The 6th Regional Stakeholder Forum

Second Regional Information Sharing on Pak Lay Prior Consultation Process

Second Draft Technical Review on Hydrology & Hydraulics

Dr. Janejira Chuthong, Chief Hydrologist, MRC Secretariat

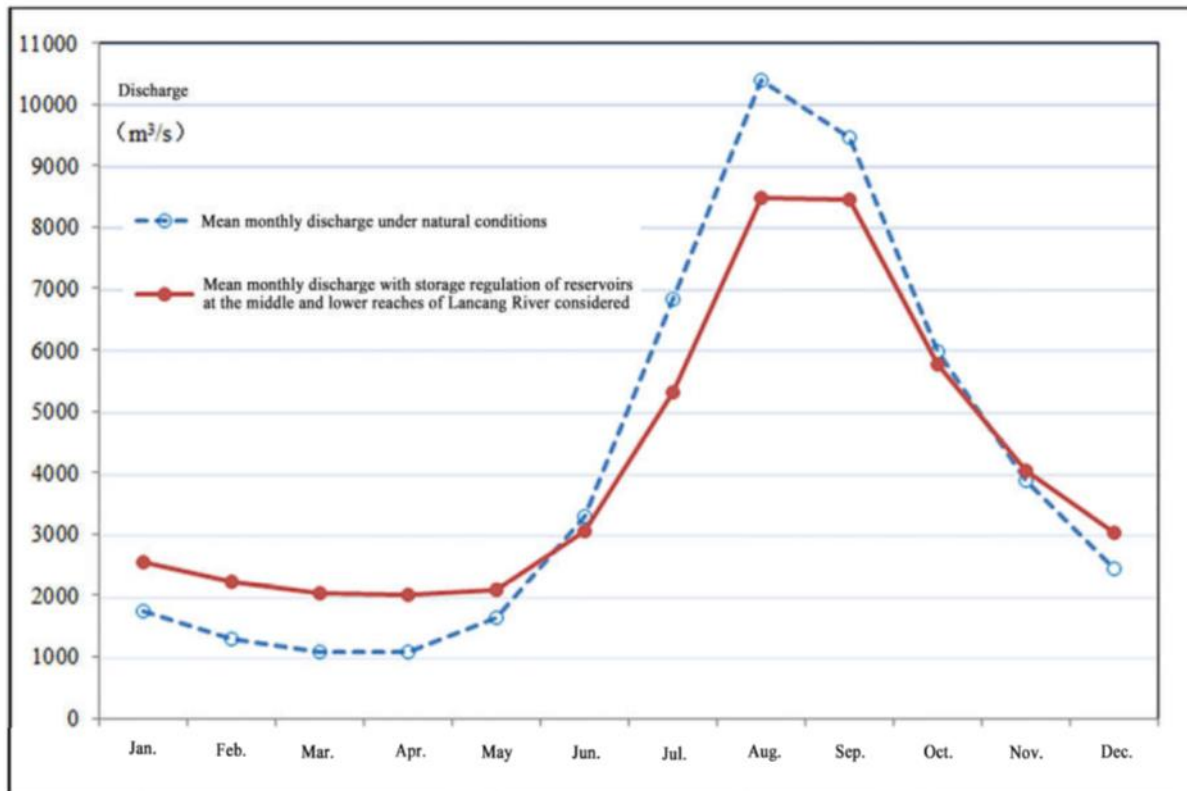
- The linear scaling approach (scaling Luang Prabang and Chiang Khan data) used to correlate the discharges is acceptable for monthly flows, but not for daily flows. These synthesized discharge data have not yet been checked with the observations at the dam site.

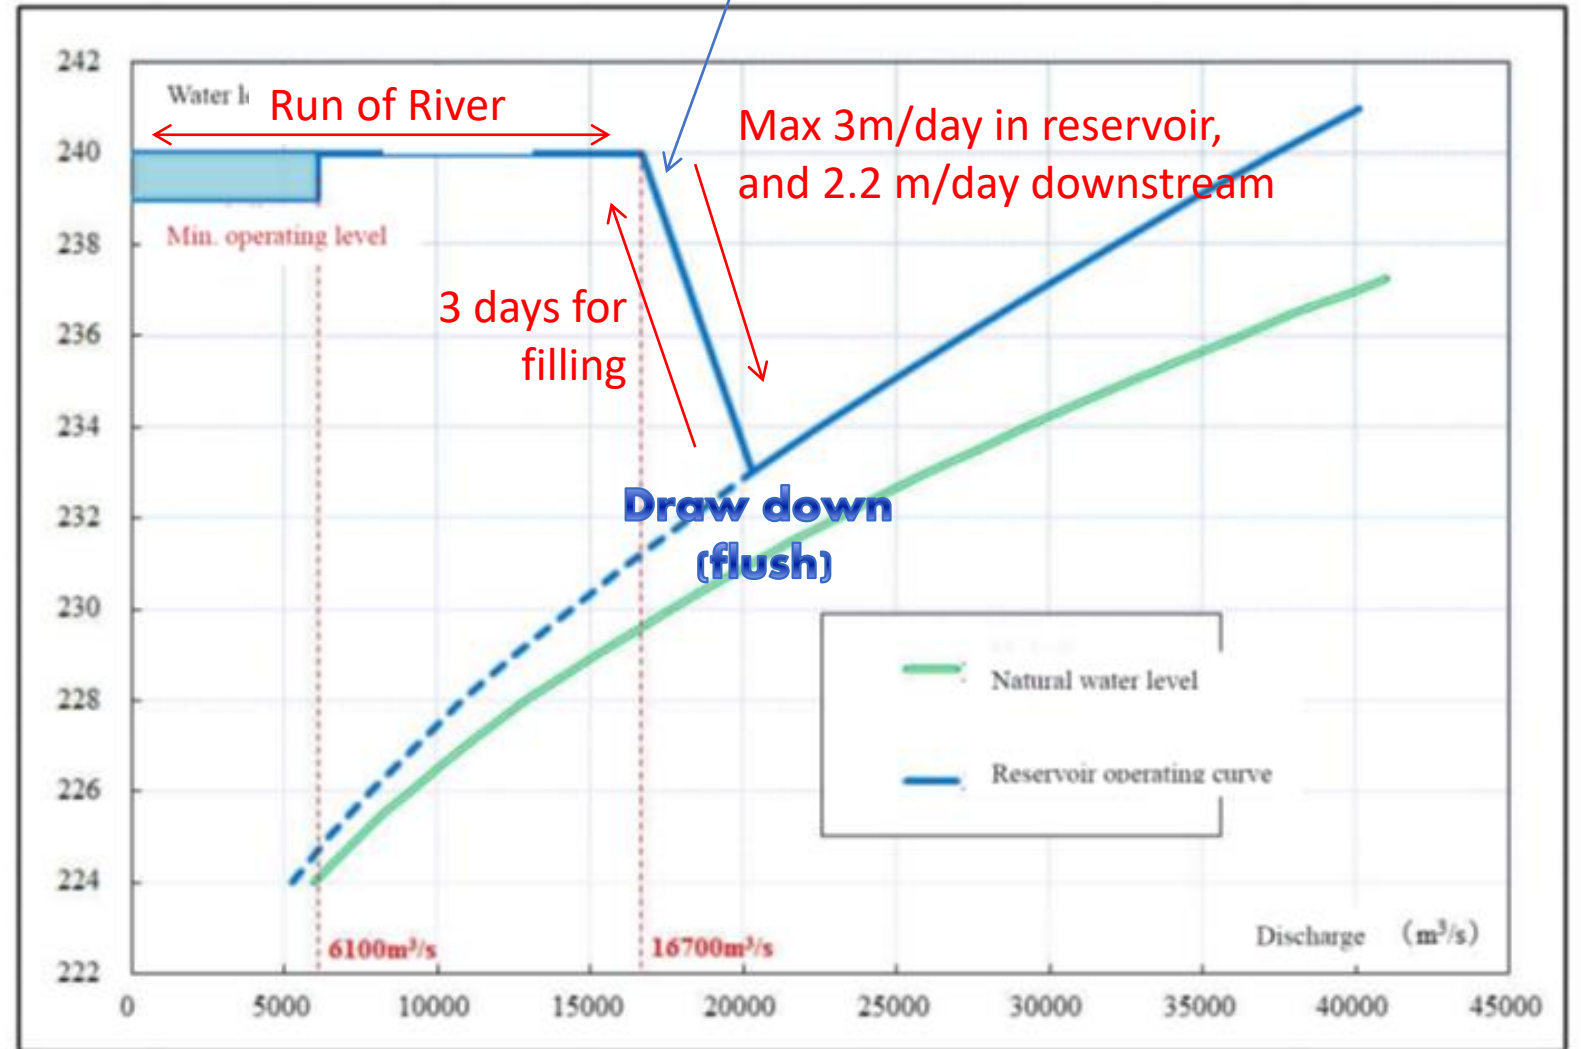
- Start emptying and filling at 16700 m³/s
- During high floods, draw down for sluicing and 'open channel'
- Most of time operation is "Run of River", and includes hydropeaking operation at low flows
- However, joint operation, transboundary impact of operations during flood, and environmental flow are not elaborated

Return period (=2 years) (may change due to future developments)
Draw down should be aligned with flushing in the cascade

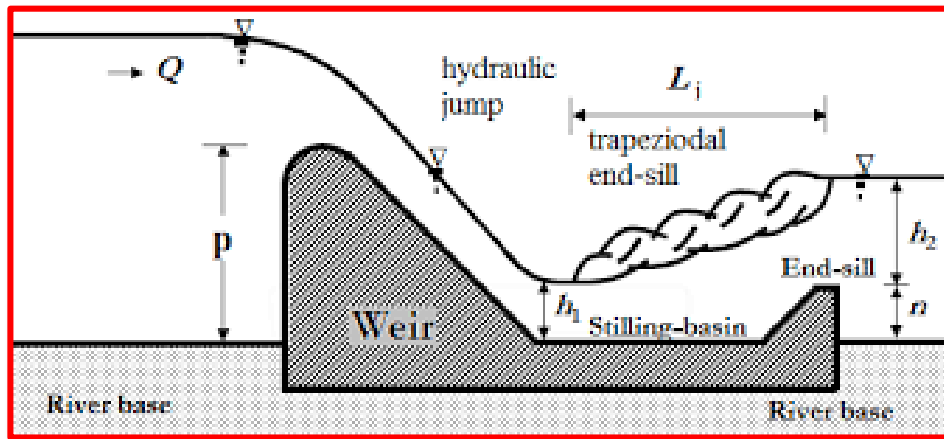
- the downstream impacts of the peaking operations, causing daily fluctuations of flows and water levels: impacts and mitigation need to be addressed in more detail
- The reduction of flow velocities in the impoundment during low flows: impacts to ecology and sediment load need to be considered properly

Graph: length L ranges from 88 to 132 m

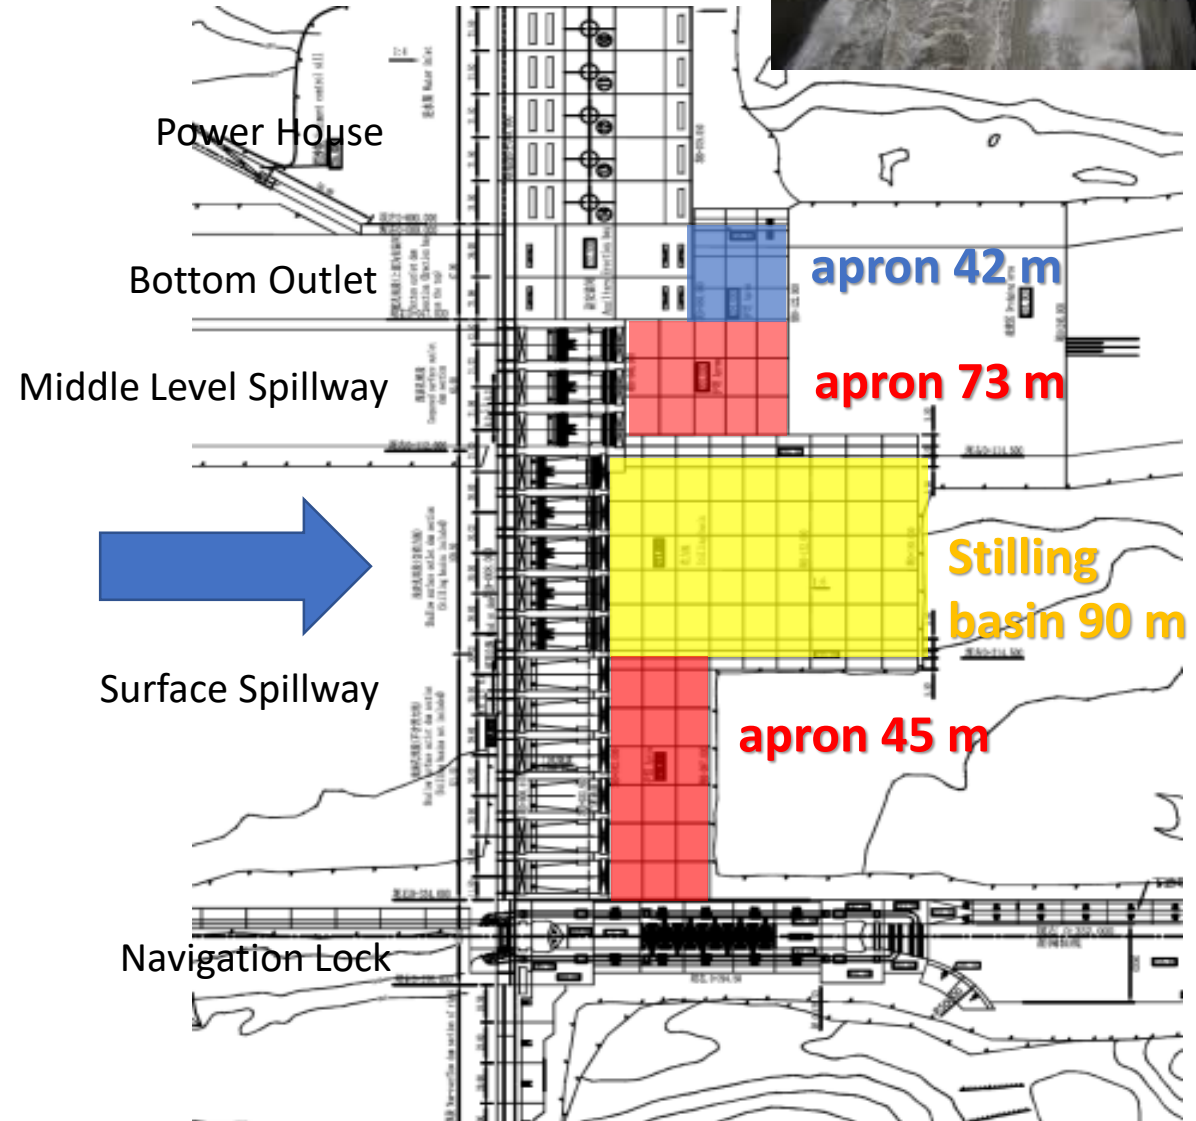
- The stilling basin and aprons downstream of the spillways are needed to protect the toe of the structure against erosion and damage by the turbulent outflows.
- More details of calculations and model tests must be presented to comprehend the chosen lengths.

The hydraulic jump determines the length of the stilling basin
